Executive Director's Recommendation

Commission Meeting: July 9, 2020

PROJECT National Institutes of Health Alzheimer's Disease and Related Dementias Temporary Facility 9000 Rockville Pike Bethesda, Maryland	NCPC FILE NUMBER 8168
SUBMITTED BY United States Department of Health and Human Services	NCPC MAP FILE NUMBER 3101.20(38.00)45113
REVIEW AUTHORITY Federal Projects in the Environs per 40 U.S.C. § 8722(b)(1)	APPLICANT'S REQUEST Approval of preliminary site and building plans
	PROPOSED ACTION Approve comments on concept plans
	ACTION ITEM TYPE Open Session

Concept Renderings

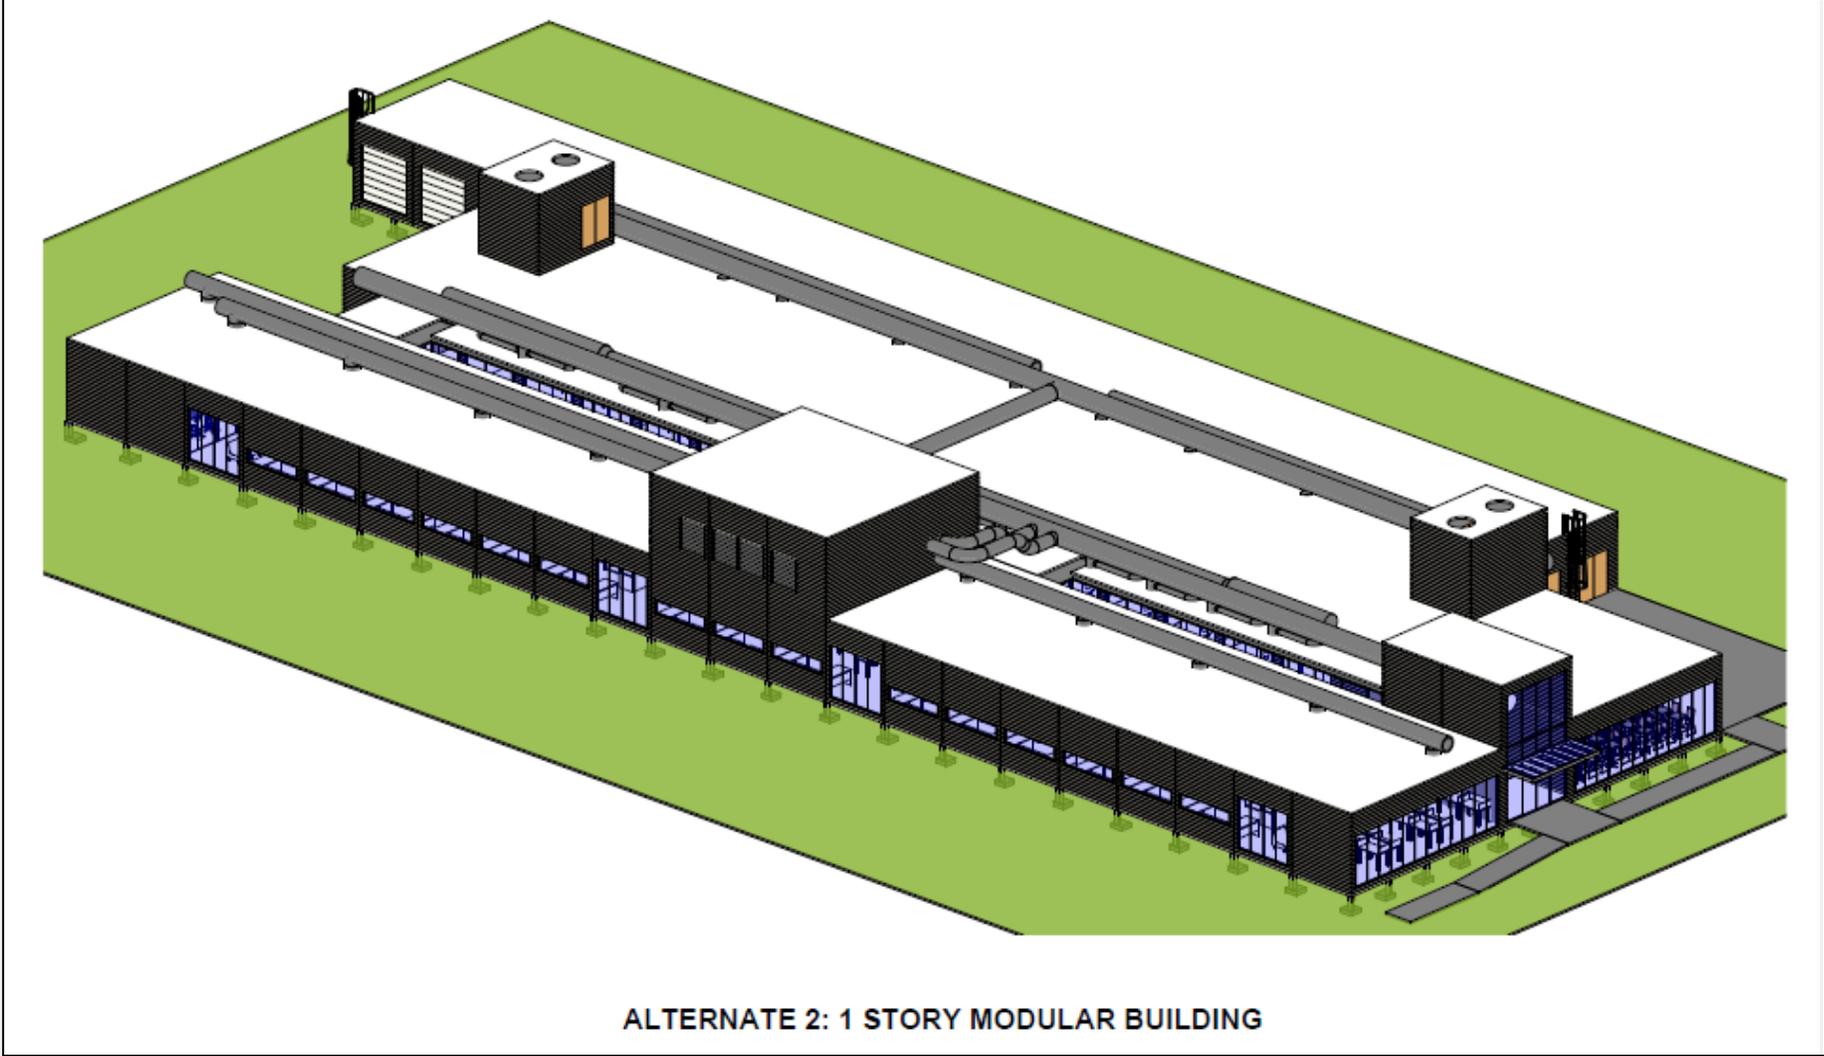
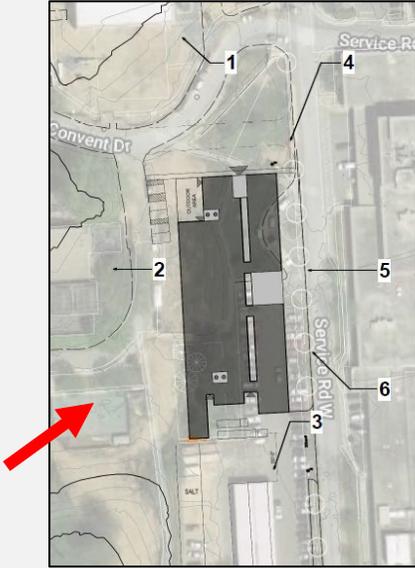
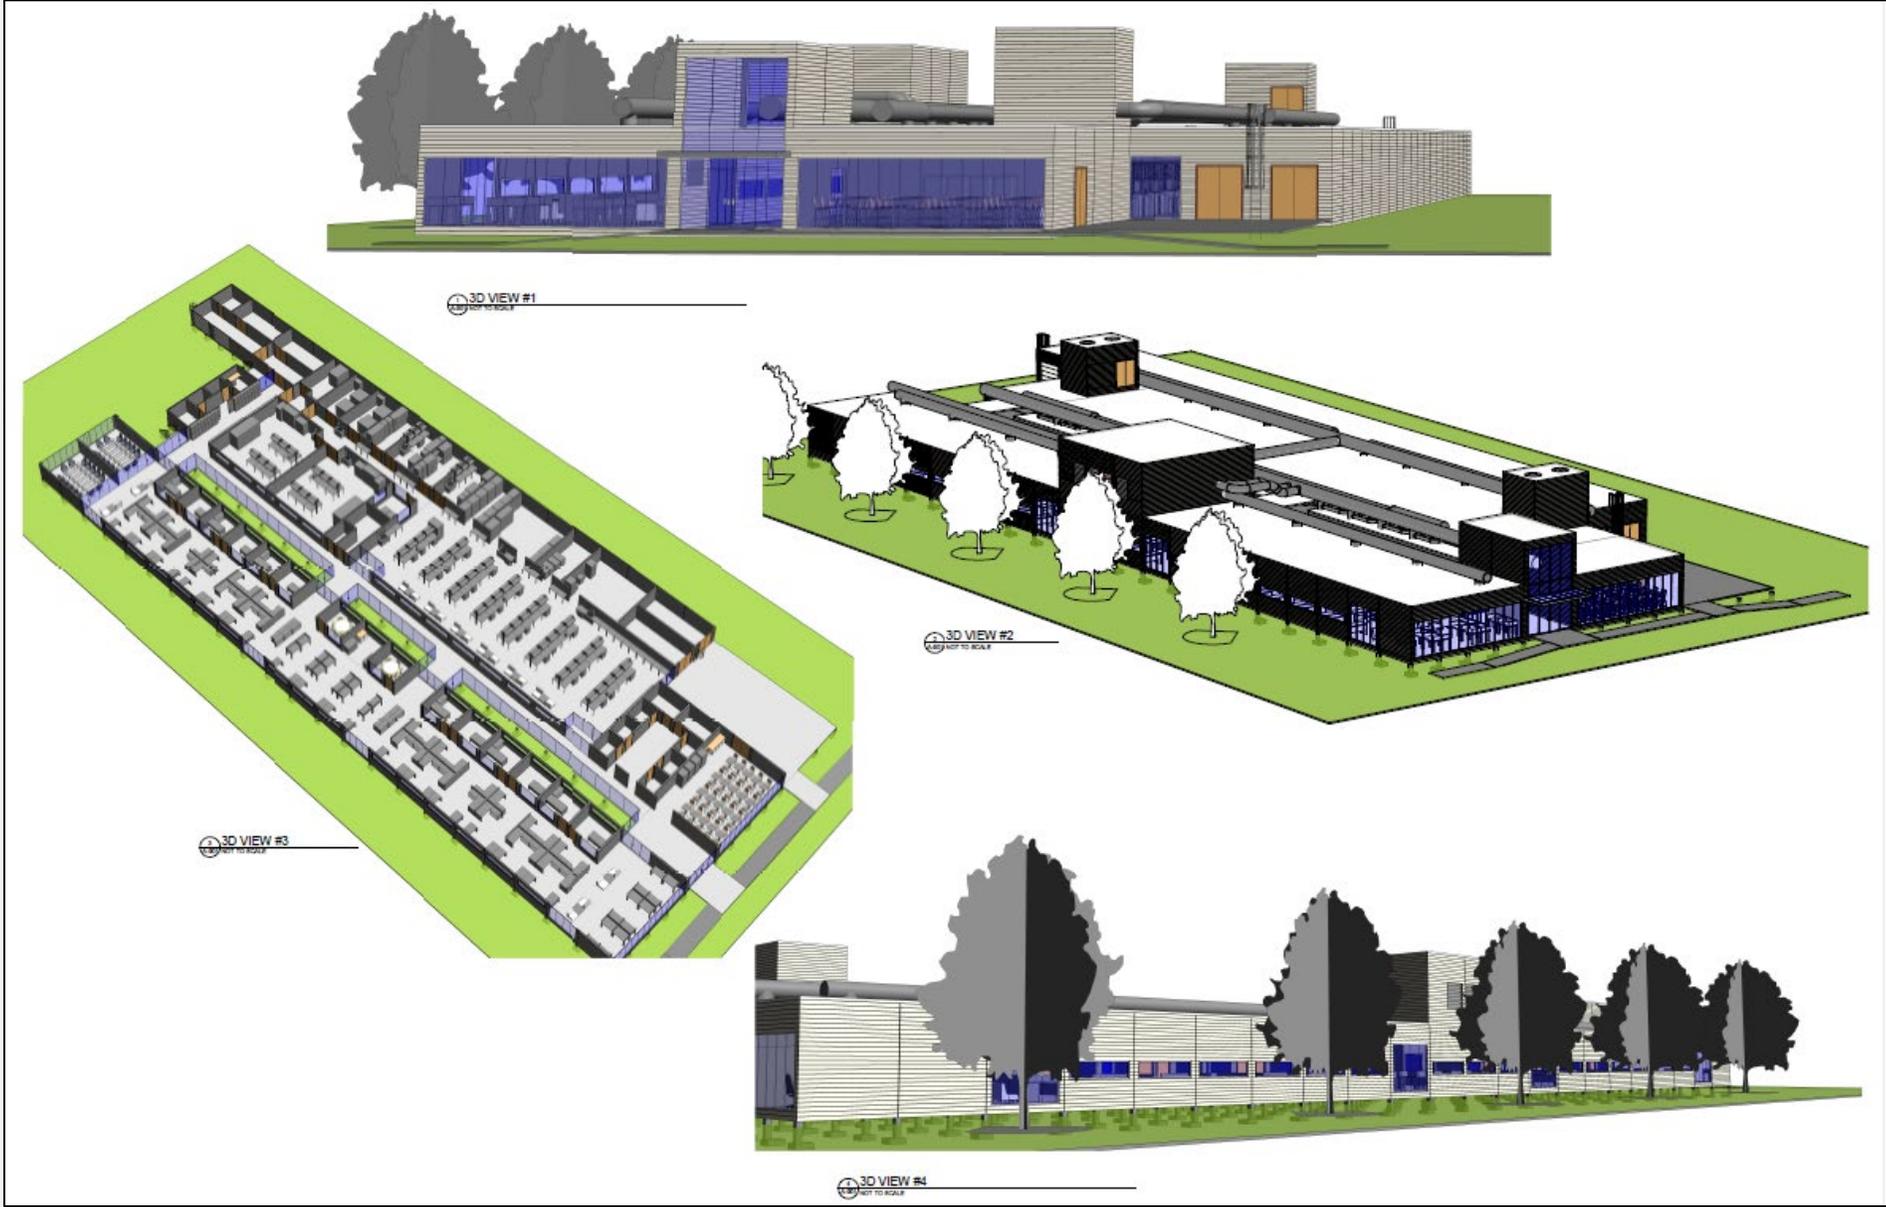
Conceptual plans show the temporary building as a straight-lined, modern-looking, modular structure with two primary parallel wings (separated by linear open courtyard spaces), with several rooftop enclosures to house laboratory-related ventilation equipment. The building would measure approximately 275 feet in length, 105 feet wide, with an elevation of 12-25 feet above ground level. Project plans show a 20-foot building setback from the Service Road West, and a 28-foot setback from Convent Drive. The project submission does not include any detailed information related to building materials, window details, or material palette.

The conceptual project submission lacks detailed information regarding building materials, textures, and colors, so NIH should include this information in the next preliminary submission. We note that two recent examples of temporary buildings had metal façades (New Cell Therapy Unit Production Facility and NIAID Bioinformatics Facility). However, staff remain unclear if the new ADRD building would also be constructed of similar materials. Therefore, staff recommends that the Commission **request detailed plans that show more refined building materials and a landscape plan.**

Site Plan

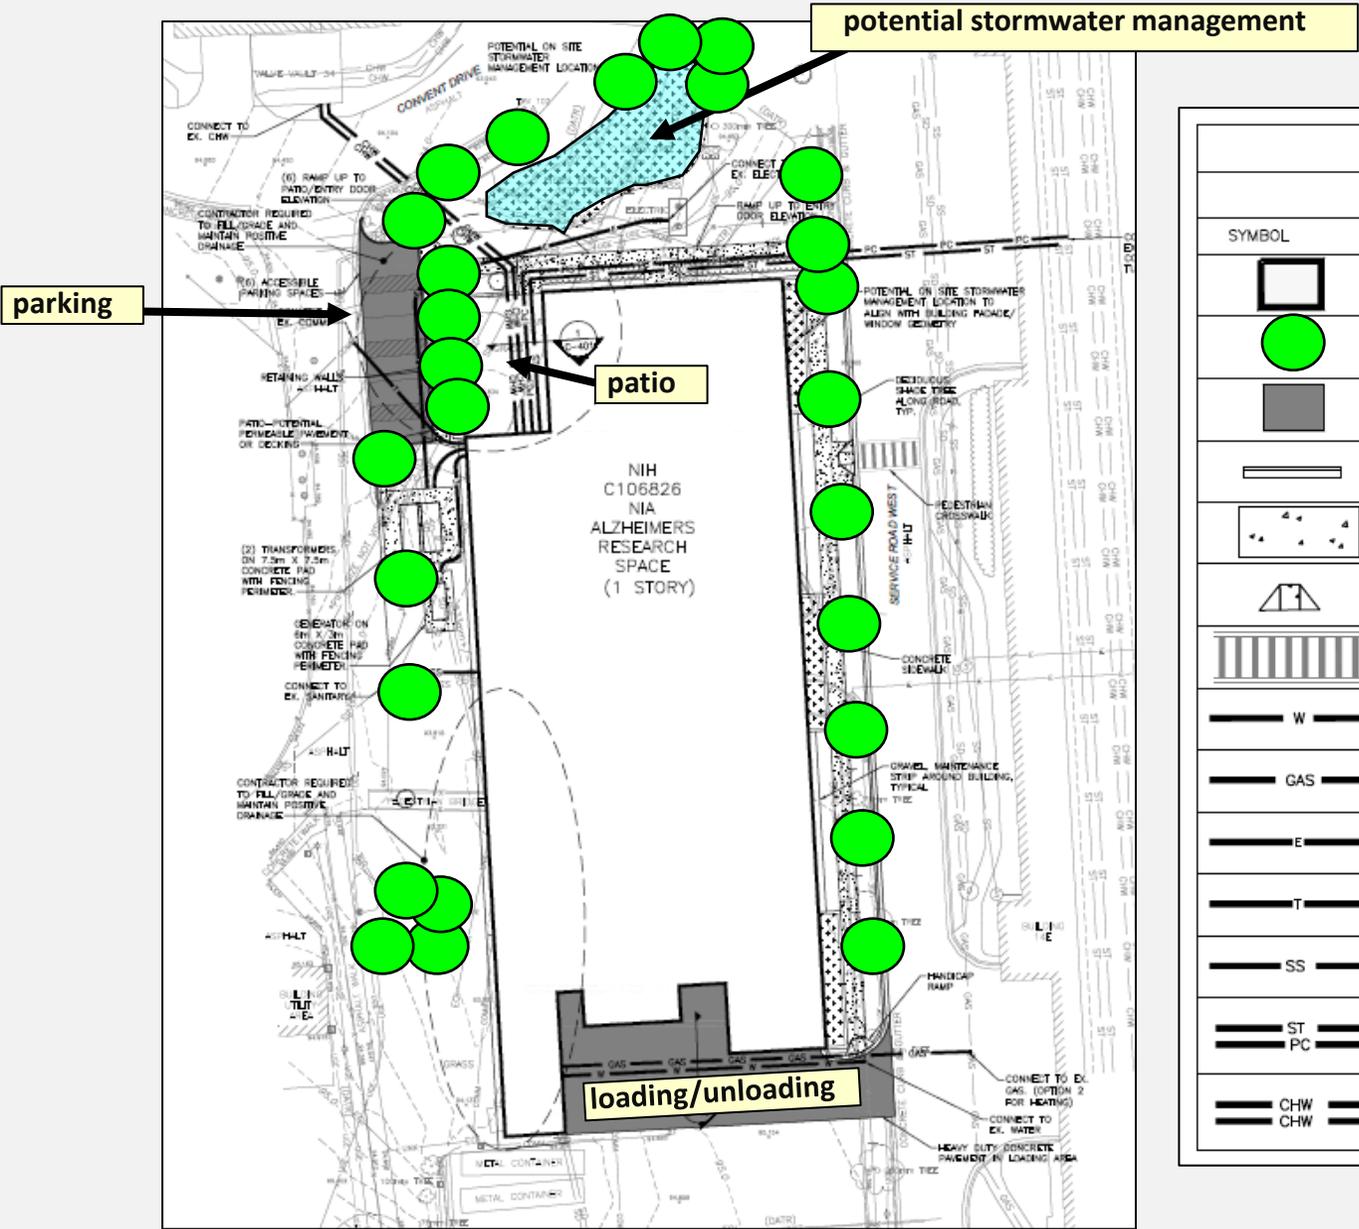
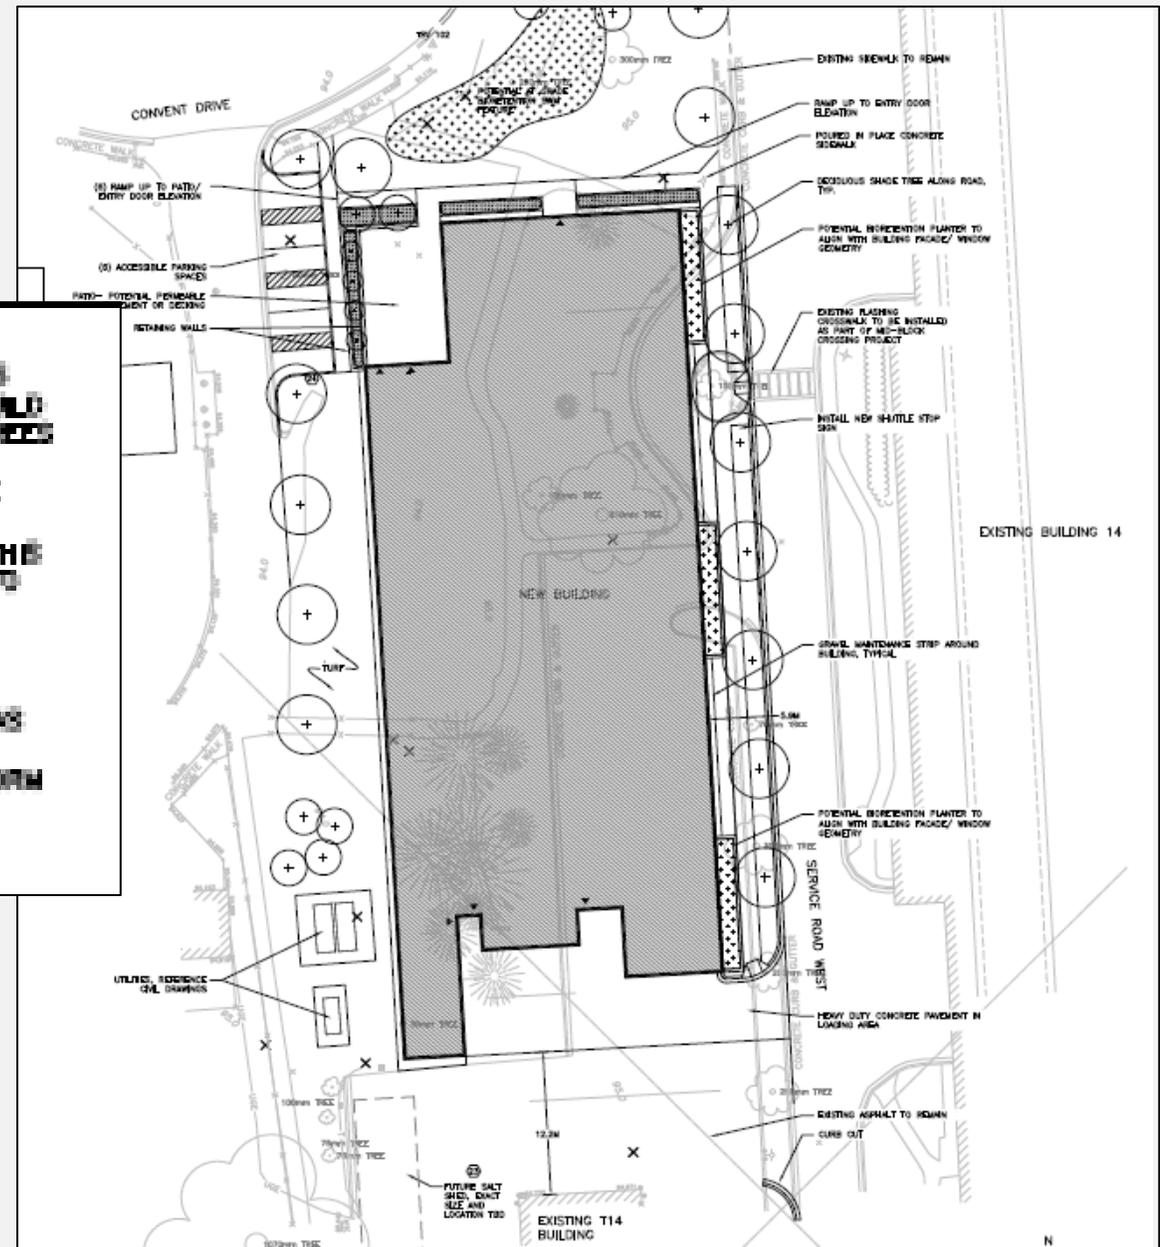
Finds the project will adhere to tree replacement policies from NIH and NCPC with a 1-to-1 tree replacement, and that NIH should consider tree locations that will minimize the need to relocate trees or replant on-site to accommodate potential future development once the temporary building is removed.

Besides the new ADRD building, the project would construct a new five-space parking lot (2 employee spaces and 3 accessible parking spaces), new sidewalks along the west, north, and east sides of the building, and a new stormwater management area in the northern part of the site. The new parking would be along the northwest side of the building (in addition to an outdoor patio area), with vehicular access from Convent Drive. The building would have loading/service access along its southside from Service Road West. The project would require removal of 37 existing spaces on-site (24 employee, 9 government vehicle, 4 accessible parking spaces), and NIH would not fully replace the parking, thereby resulting in a net reduction of 31 employee spaces. The site

plan shows 27 on-site trees located to the west, north, and east sides of the building, with smaller planting beds along the east, north, and west edges of the building. The submission does not include any additional detailed landscaping information.

The location and building orientation appear to be reasonable given the configuration and size of the project site. The project will replace 27 existing trees with 27 new trees on the site, which will be consistent with NIH's one-for-one tree replacement policy and NCPC's "no net loss" tree policy (FE.G.2). The proposed tree locations appear to be reasonable given the ADRD building placement; however, NIH should consider its proposed tree locations within the context of the master plan so that tree removal and/or relocation is minimized. As a potential future site for fuel tanks, mature trees would be helpful in shielding the tanks from other nearby development. Staff recommends that the Commission **find the project will adhere to tree replacement policies from NIH and NCPC with a 1-to-1 tree replacement, and that NIH should consider tree locations that will minimize the need to relocate trees or replant on-site to accommodate potential future development once the temporary building is removed.**
